LG inverter modification “I”

Ref. nr. SCC_73709

Doc. version 1.2

COMPONENT KIT (996500095005)

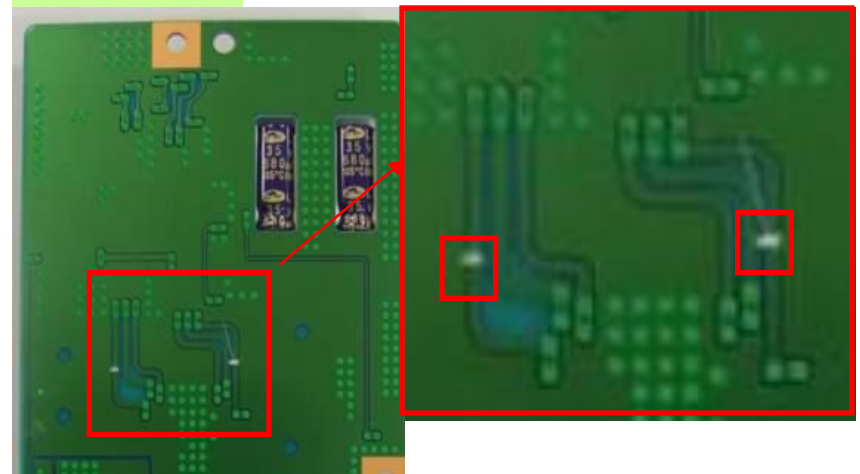
Cut tracks:

- Cut the SW1 & SW2 tracks on both inverters.
- **Confirm that there are no short circuits with metal pieces of tracks, and there is no damage to other tracks !**

STEP 2.2

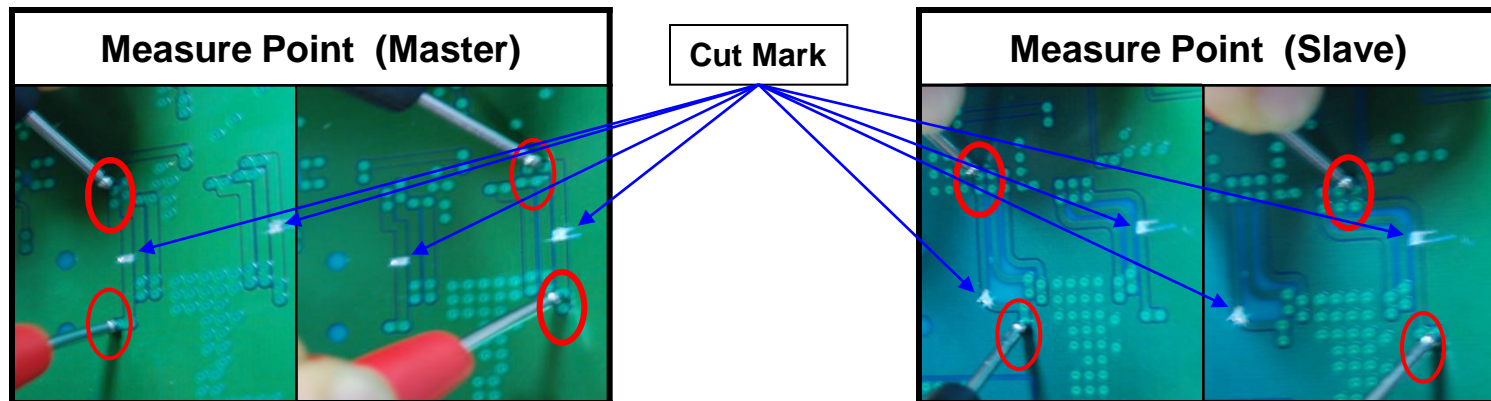
2. Check the resistance between two 'via' holes of the cut SW line:

→ Measure the resistance of the cutted SW1 & SW2 line through 'via' holes with a DVM (Digital Volt Meter).

Case 1 > Several tens of $k\Omega$: Line cut well.

Case 2 > under $1\ \Omega$: Line short.

※ After attaching the resistor, the resistance should be $4.2 \sim 5.2\ \Omega$.

Check pattern damage of parallel tracks

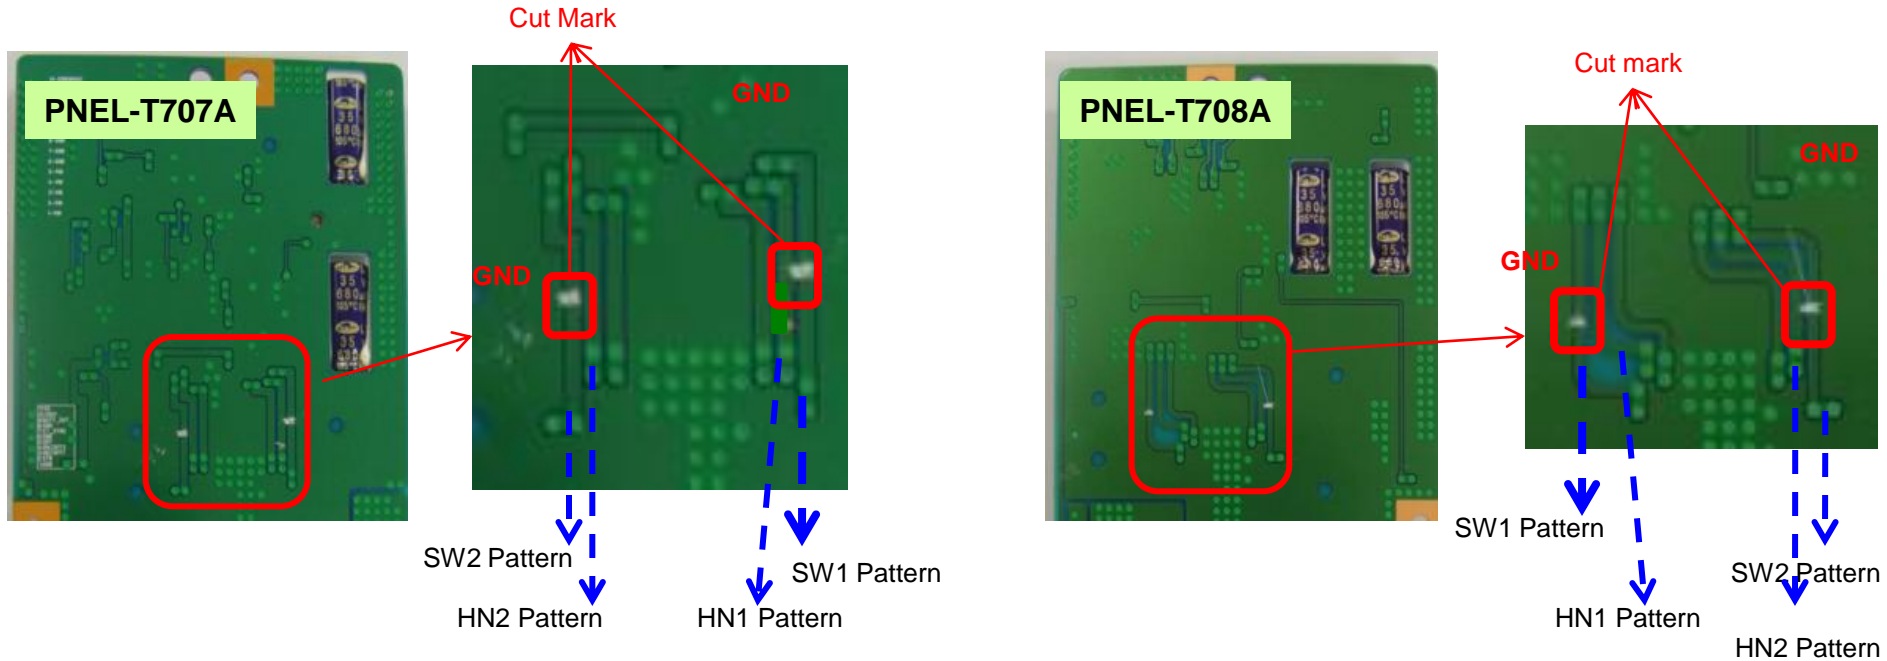
Parallel tracks of SW line are HN1, HN2 and GND tracks.

- Case1> If cut the HN track by mistake → Cause of Inverter malfunction.
 - Check : HN line's resistance should be under 0.5Ω when measured with DVM (resistance b.t.w. via holes of HN line).
- Case2> Damage on GND track by mistake → No affect to Inverter function.
 - No damage on GND function because GND track is spread widely.

Solder resistors on board PNEL-T708A:

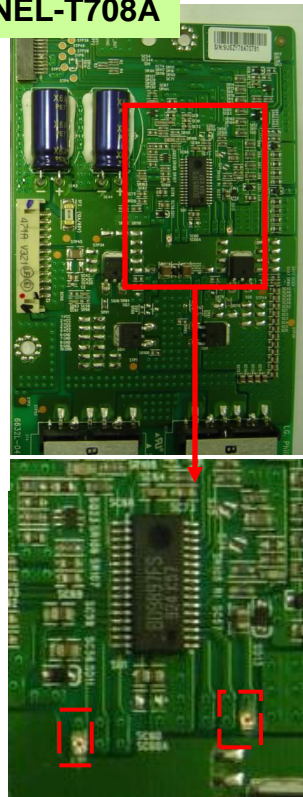
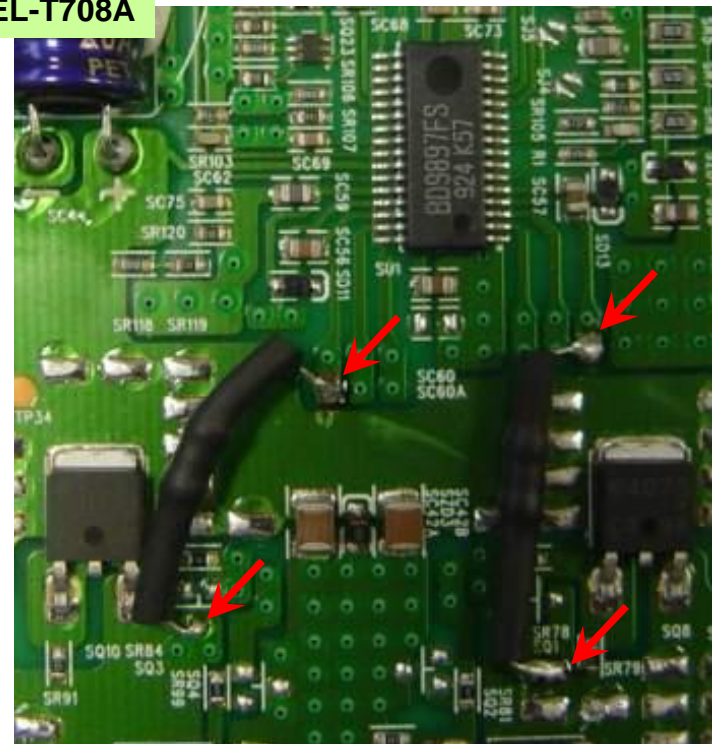
- Remove the coating/varnish on solder point to reveal the copper pad.
- Solder resistor (DIP type resistors (4.7 Ω) with shrink tube (20 mm)) on solder points (red marks).

Solder resistors on board PNEL-T707A:

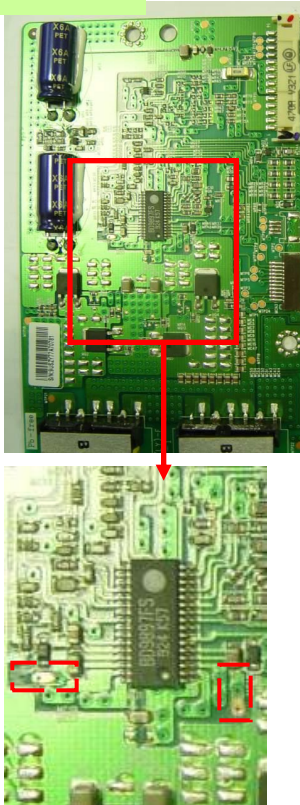
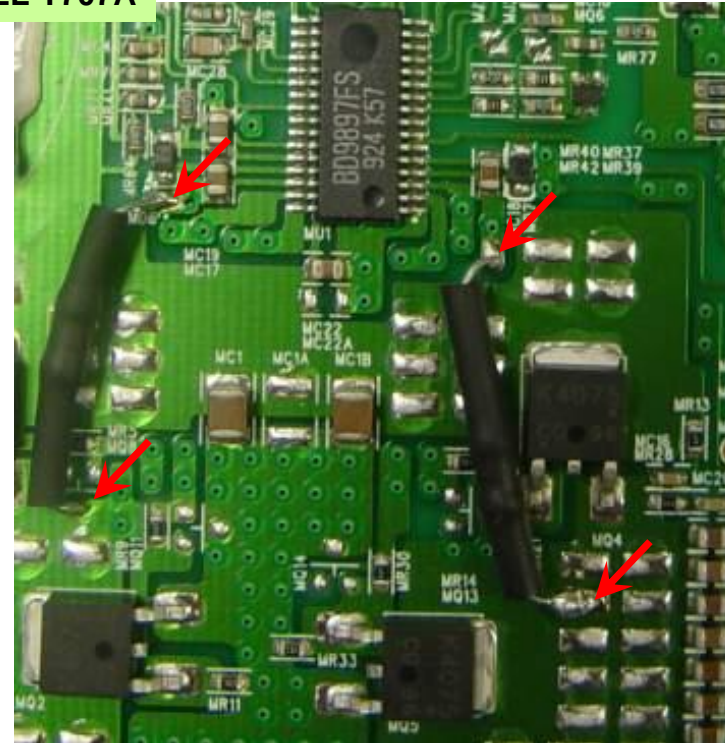
- Remove the coating/varnish on solder point to reveal the copper pad.
- Solder resistor (DIP type resistors (4.7 Ω) with shrink tube (20 mm)) on solder points (red marks).

Side view dimension of implemented inverter

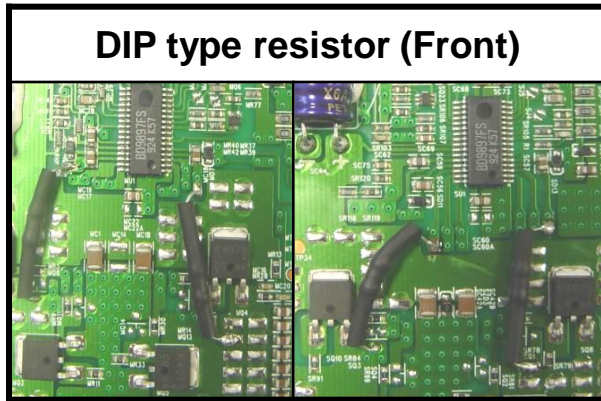
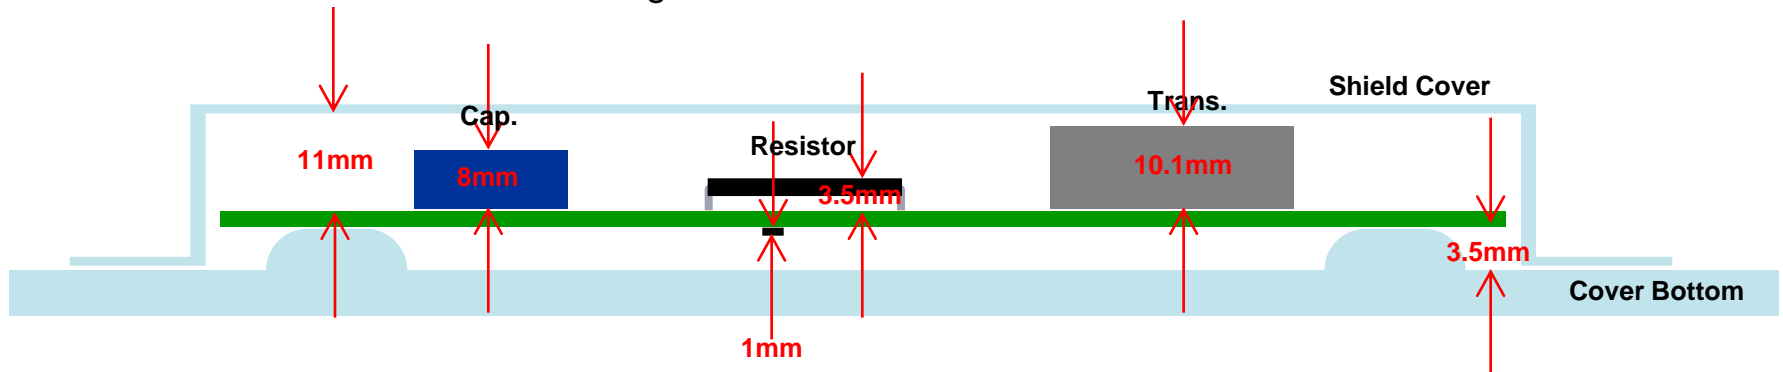
→ Take care that the height of the DIP type resistor is below the height of the transformer because of the metal shielding on the inverter boards.

Solder SMD resistors on board PNEL-T707A and PNEL-T708A:

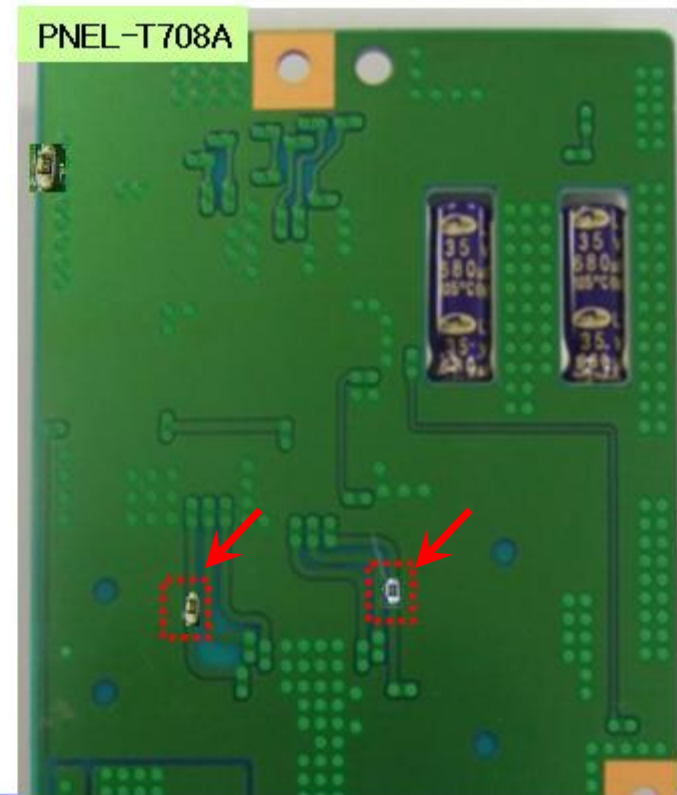
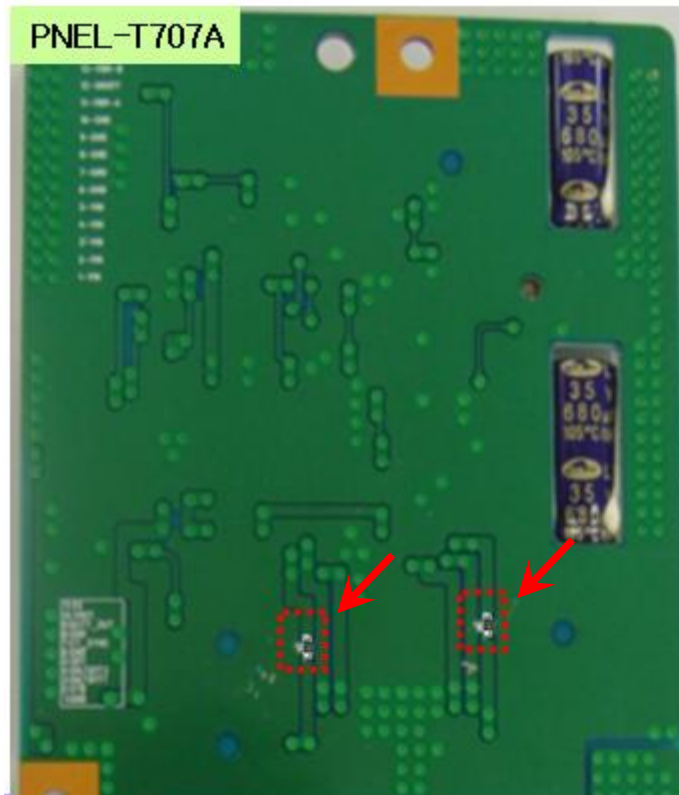
- Remove the coating/varnish on solder points to reveal the copper.
- Solder SMD resistor on created solder pads (red marks).

MLCC position

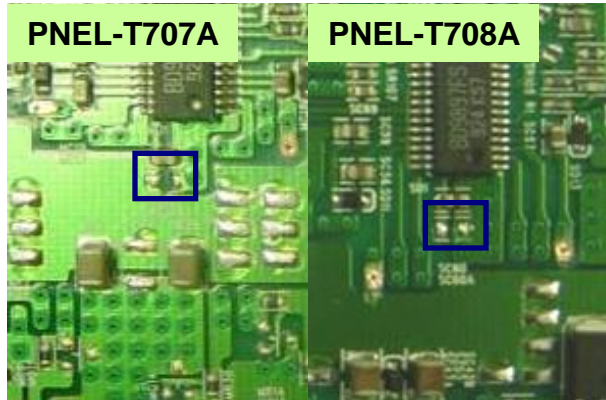
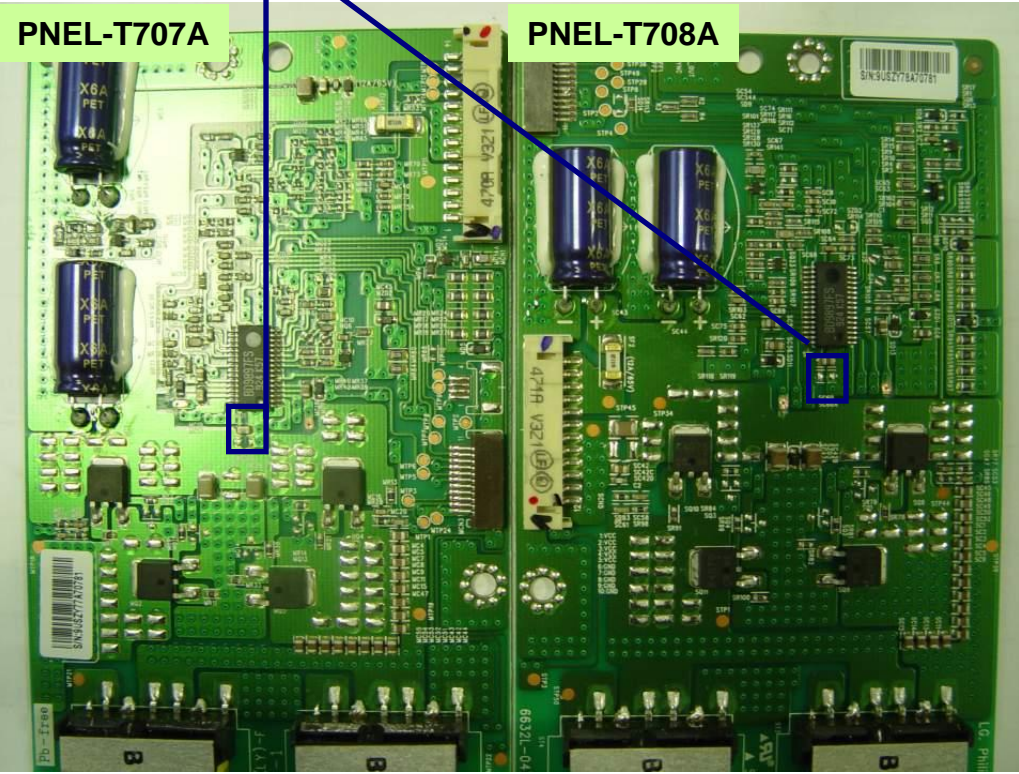
Solder capacitor (MLCC) on PNEL-T707A and PNEL-T708A:
 -Solder capacitor MLCC (100 pF) on blue indicated position.
